IN THE MATTER of the hearing of submissions on Plan Change 14 (Housing
and Business Choice) to the Christchurch District Plan

**STATEMENT OF PRIMARY EVIDENCE OF CLARA CAPONI ON BEHALF OF
CHRISTCHURCH CITY COUNCIL**

HERITAGE ENGINEERING

CITY-WIDE QUALIFYING MATTERS: HISTORIC HERITAGE

sketch sheet

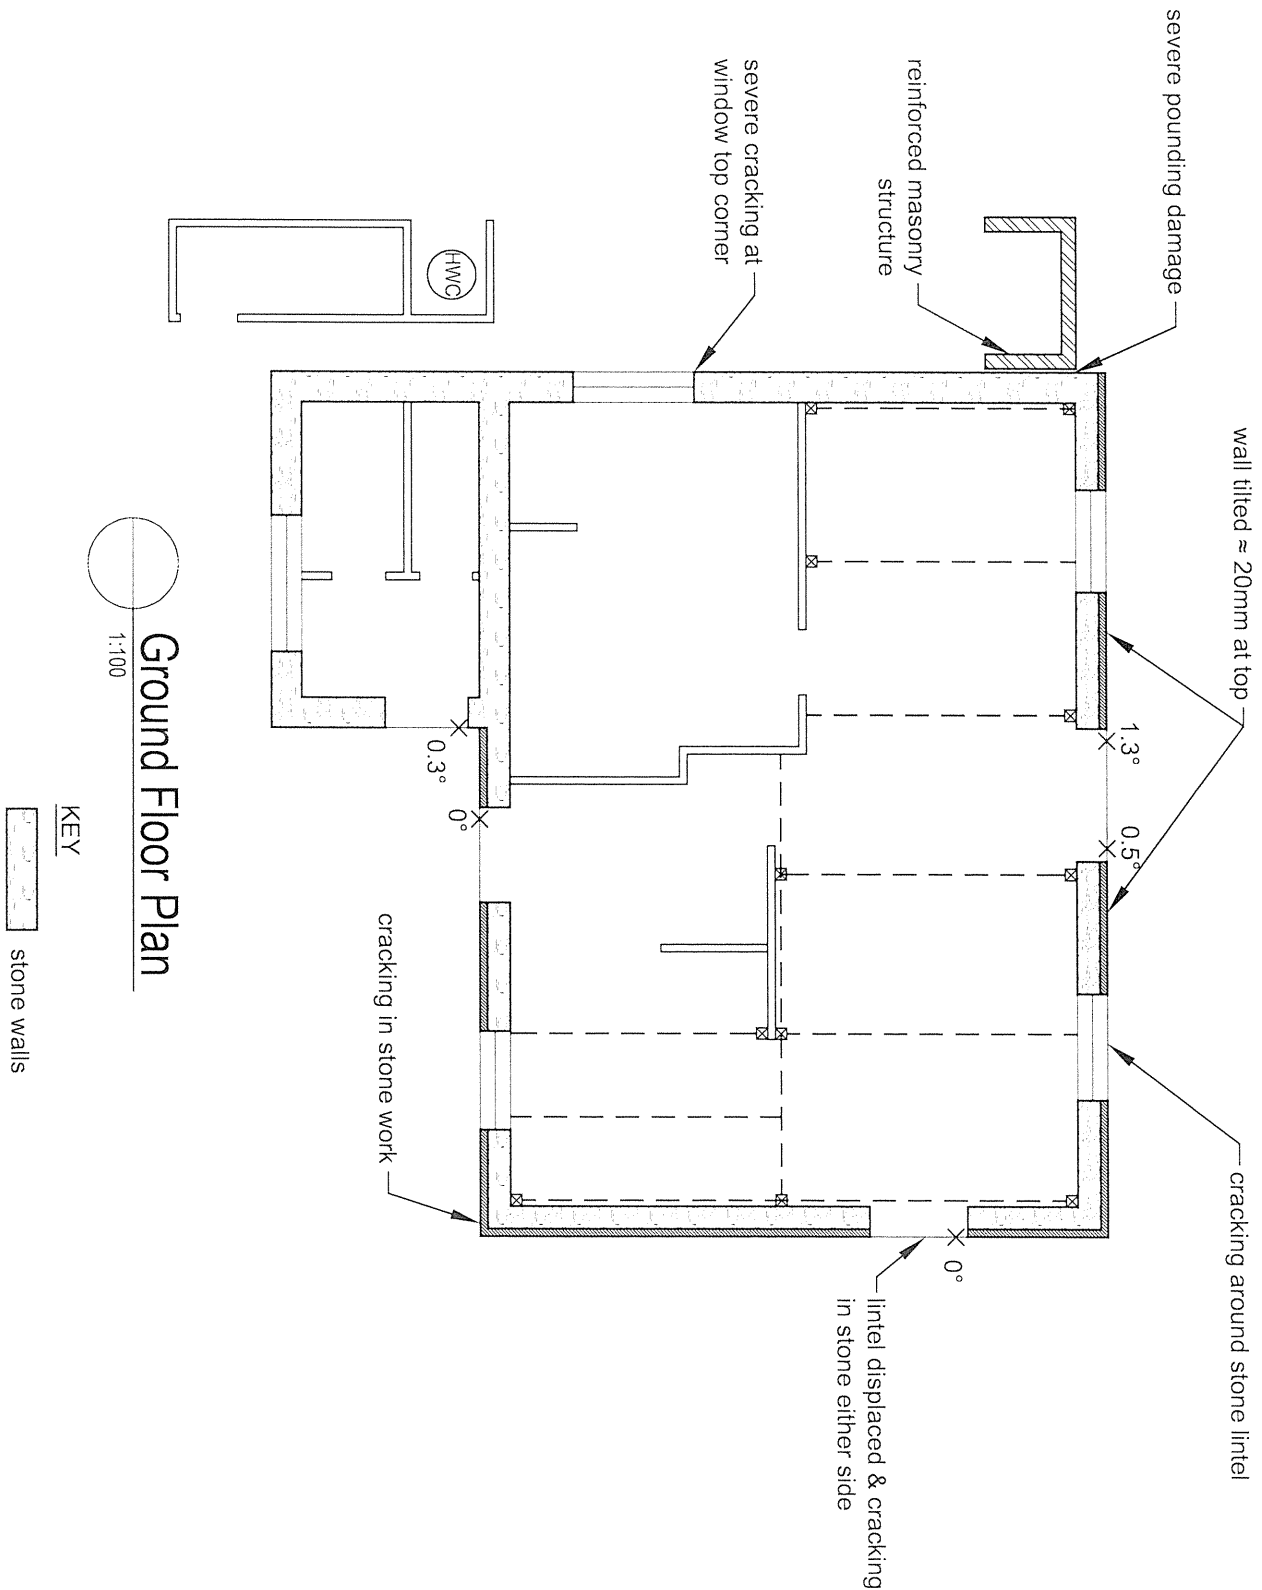
General Comment severe cracking in external stone walls

GROUND FLOOR
PLAN

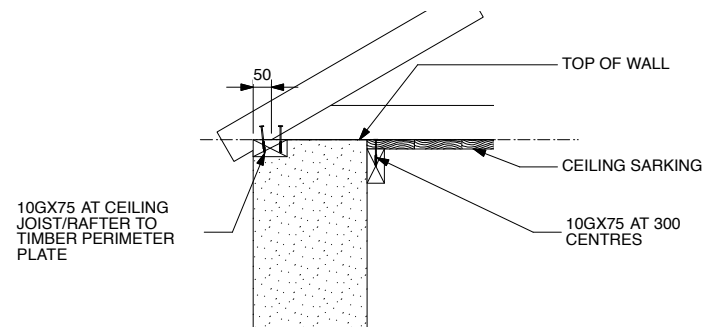
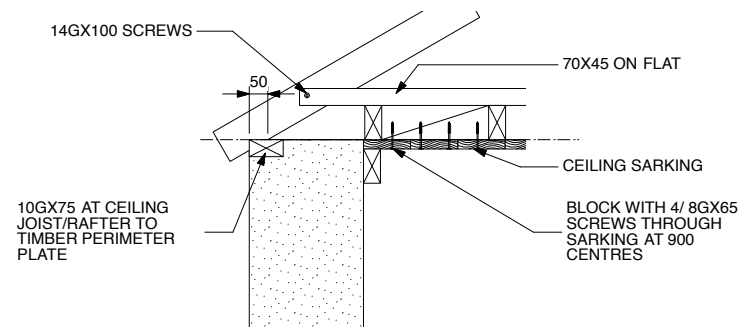
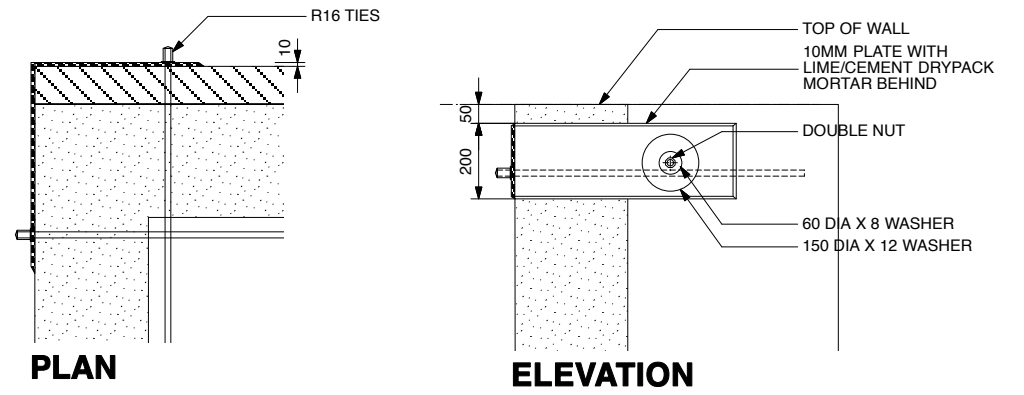
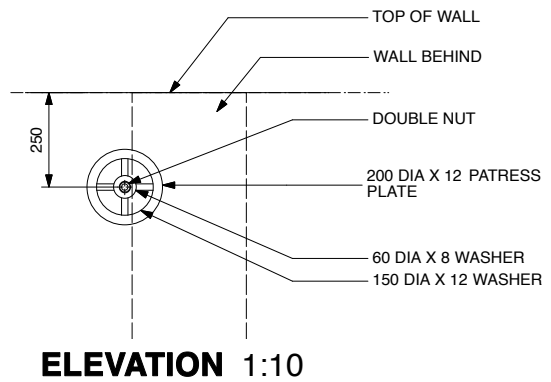
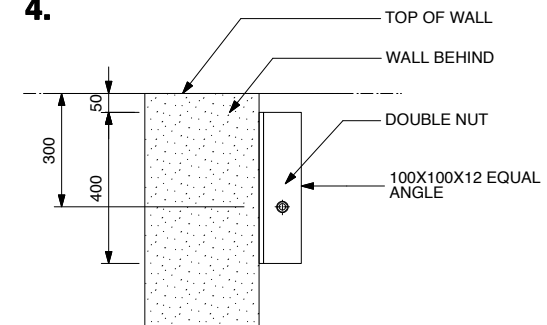
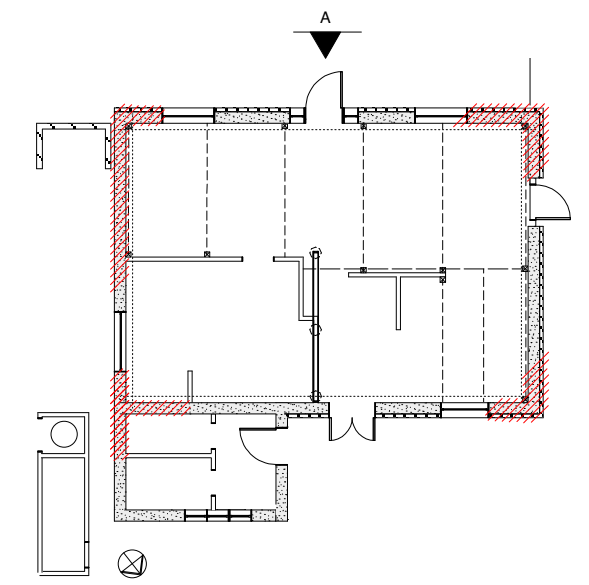
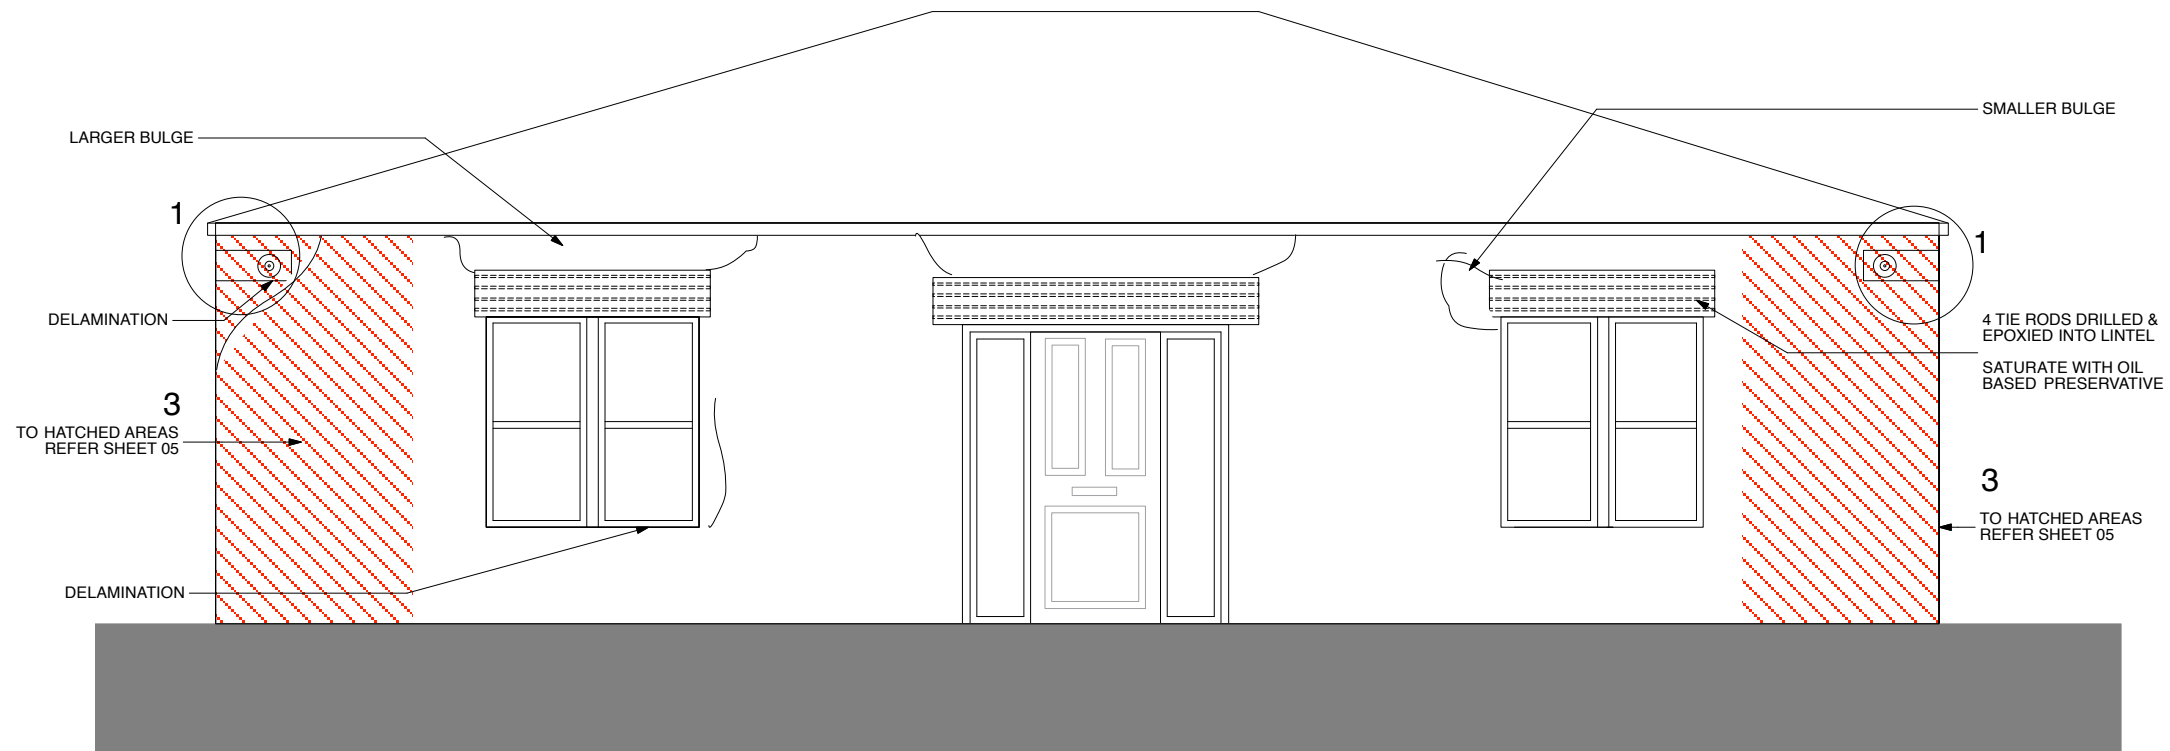
86. There are viable engineering options to repair the building to a safe and useable condition. The design approach proposed by Dunning and Thornton could provide an effective and heritage-sympathetic way to strengthen the building. Therefore, in my opinion there is no engineering reason why the building should be removed from the Schedule.

Photo 6 – View from East wall with new cracks.

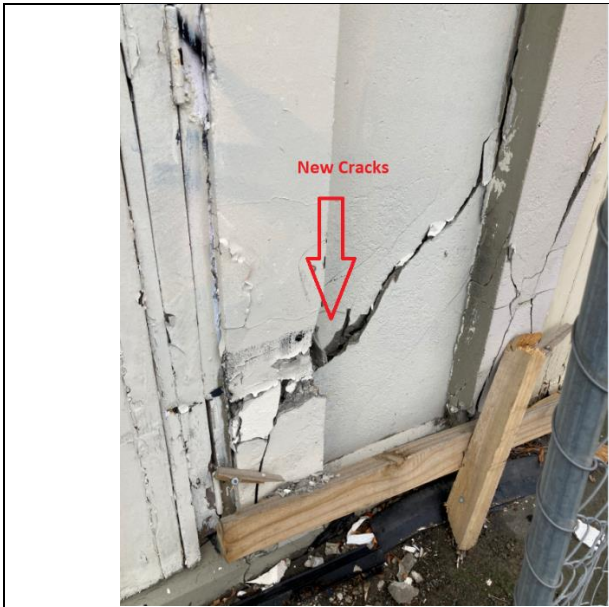
3.1. New cracks were observed at the East wall (refer to photos 6 & 7) of the building. At time of this writing, I was informed by yourself that a car (vehicle type unknown) crashed on this wall. The columns and adjacent walls appeared to be badly damaged by this crash, with visibly shear cracks showing. It is somewhat unusual to see such significant cracks from a car crash. A probable explanation is that there could be some undetected shear cracks from previous events on this location (such as earthquake shakes) and this crash somehow compounded those cracks. This also inferred that there could be other damages elsewhere in the building which may have gone unnoticed.
